M12 BRUSHLESS COMPACT 2 SPEED SCREWDRIVER

REVISED BULLETIN	DATE
54-42-3300	Feb. 2014

CATALOG NO.	2402-20	STARTING SERIAL NO.	E26B

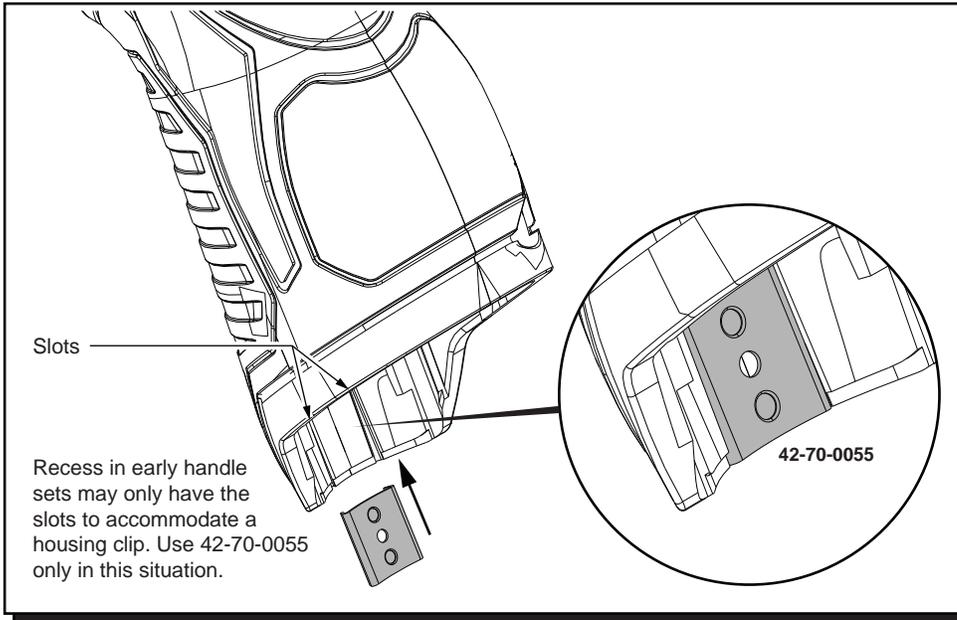
Early M12™ Handle Sets utilize **Housing Connection Clip No. 42-70-0055.** Install this clip design by aligning the side rails of the clip with the two slots in the handle set. Gently push into place with the aid of a small flat blade screwdriver or a similar instrument. Be sure that the clip is properly seated in both slots and that the clip is flush to sub-flush to the end of the handle set. To remove the clip, use the same small flat blade screwdriver or a similar instrument and push the clip out of the handle set. If the clip is loose or will not stay in place, a needle nose pliers can be used to gently bend/pinch the side rails of the clip. If the clip is damaged do not use, replace with a new 42-70-0055 housing clip.

Recess in early handle sets may only have the slots to accommodate a housing clip. Use 42-70-0055 only in this situation.

42-70-0055

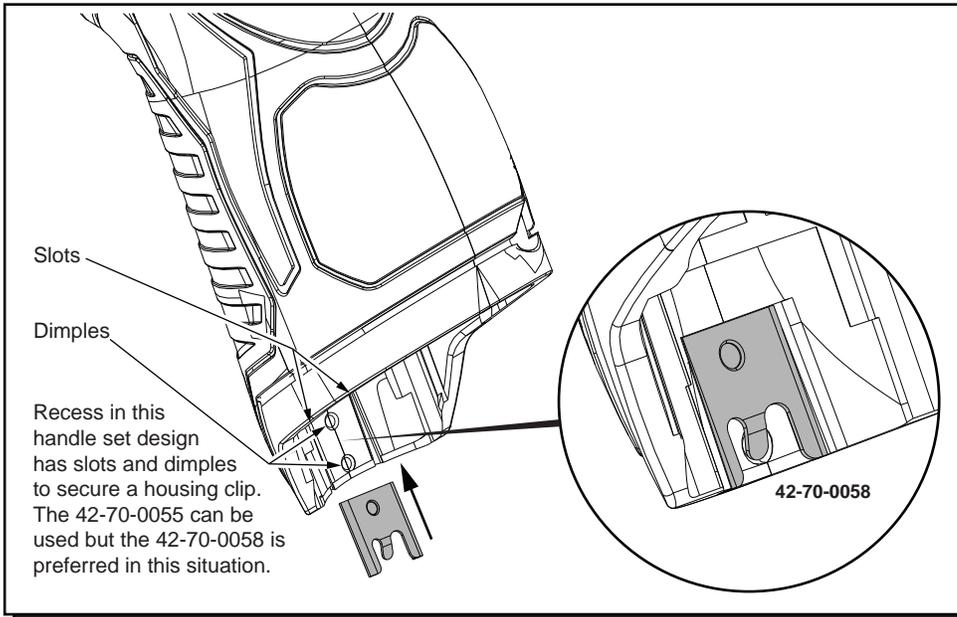
Updated M12™ Handle Sets utilize **Housing Connection Clips No. 42-70-0055 and 42-70-0058. (The 42-70-0058 is a preferred upgrade).** Install this clip design by aligning the side rails of the clip with the two slots in the handle set. Gently push into place with the aid of a small flat blade screwdriver or a similar instrument. Be sure that the clip is properly seated in both slots and that the tab of the clip snaps down in the round dimpled cavity of the handle set. Be sure that the clip is flush to sub-flush to the end of the handle set. To remove the clip, use the same small flat blade screwdriver or a similar instrument and lift up on the clip tab while pushing the clip out of the handle set. Use a needle nose pliers to gently rebend the clip tab if necessary. If the tab on the clip is damaged during this process and is loose or will not stay in place, replace with a new 42-70-0058 clip.

Recess in this handle set design has slots and dimples to secure a housing clip. The 42-70-0055 can be used but the 42-70-0058 is preferred in this situation.

42-70-0058

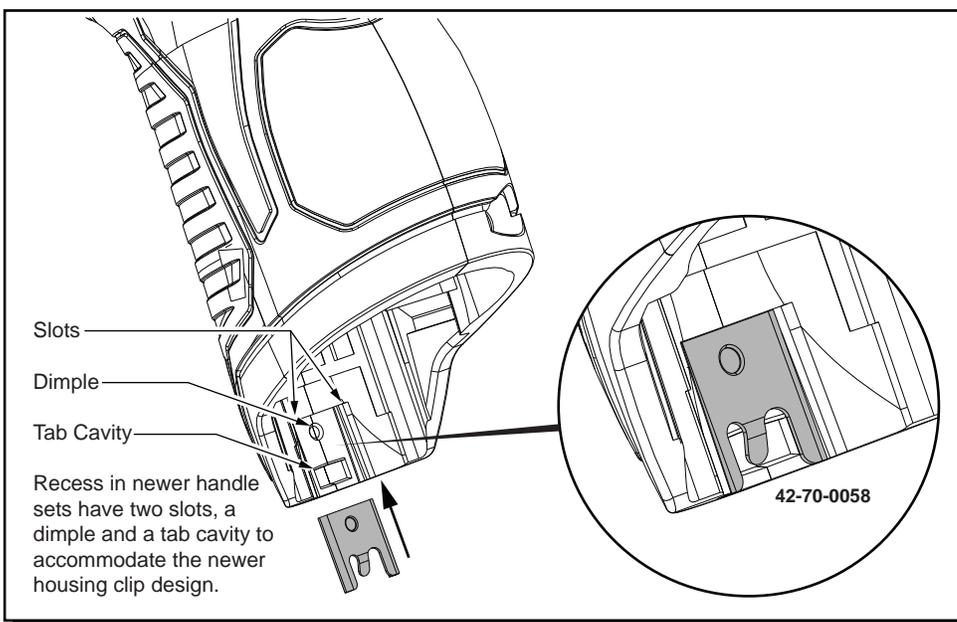
Newer M12™ Handle Sets utilize **Housing Connection Clip No. 42-70-0058.** Install this clip design by aligning the side rails of the clip with the two slots in the handle set. Gently push into place with the aid of a small flat blade screwdriver or a similar instrument. Be sure that the clip is properly seated in both slots and that the tab of the clip snaps down in the rectangular cavity of the handle set. Be sure that the clip is flush to sub-flush to the end of the handle set. To remove the clip, use the same small flat blade screwdriver or a similar instrument and lift the clip tab out of the cavity while pushing the clip out of the handle set. Use a needle nose pliers to gently rebend the clip tab if necessary. If the tab on the clip is damaged during this process and is loose or will not stay in place, replace with a new 42-70-0058 clip.

Recess in newer handle sets have two slots, a dimple and a tab cavity to accommodate the newer housing clip design.
